PUBLIC WORKS  
 8401 Laguna Palms Way  
 Elk Grove, California 95758

## Standards Update Transmittal

Reference Number: 2024-15  
 Standards: Standard Construction Specifications, Section 34-1 and 34-2 and Standard Drawings T-6B and T-6C (new)

**T - 6B**

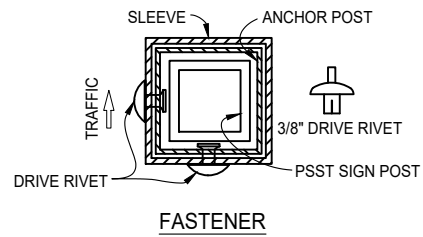
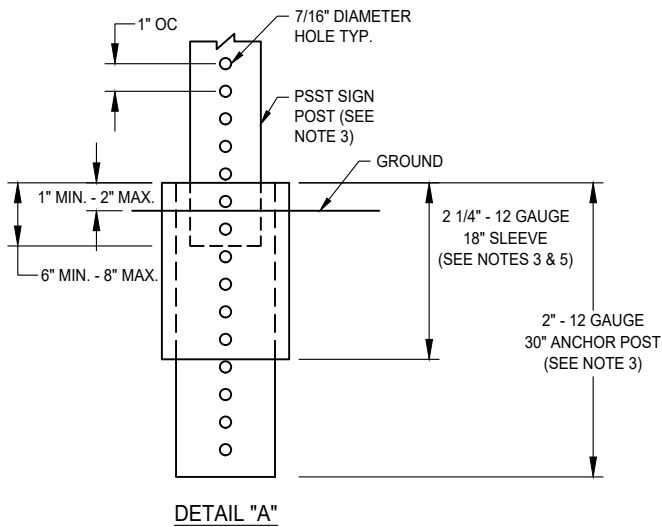
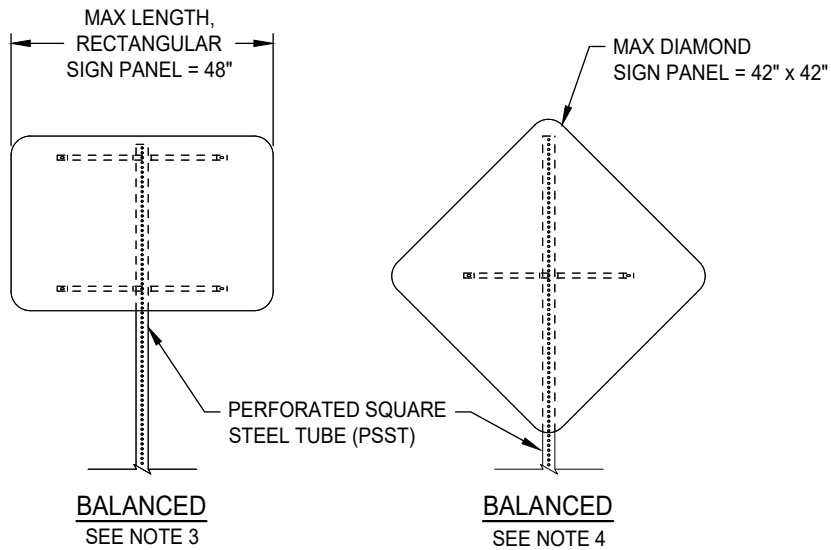
2. Modifications to Standard Drawing
  - a. Rename Standard Drawing T-6B to Signs Post
  - b. Remove detail B and update detail sheet with Caltrans Revised Standard Plan RSP – RS5 details.

- c. Add details and table to address two sign post.
  - d. Update notes on Standard Plan sheet T-6B
  - e. New Standard Plan T-6C titled Sign Back Bracing. The is for single sign post back bracing.

- a. Rename the detail sheet T-6B
- b. Replace the post foundation detail with the current Caltrans detail.
- c. Provide detail information for two sign post.
- d. Update the detail sheet notes.
- e. Created a new detail sheet (T-6C) that details back bracing for signs.
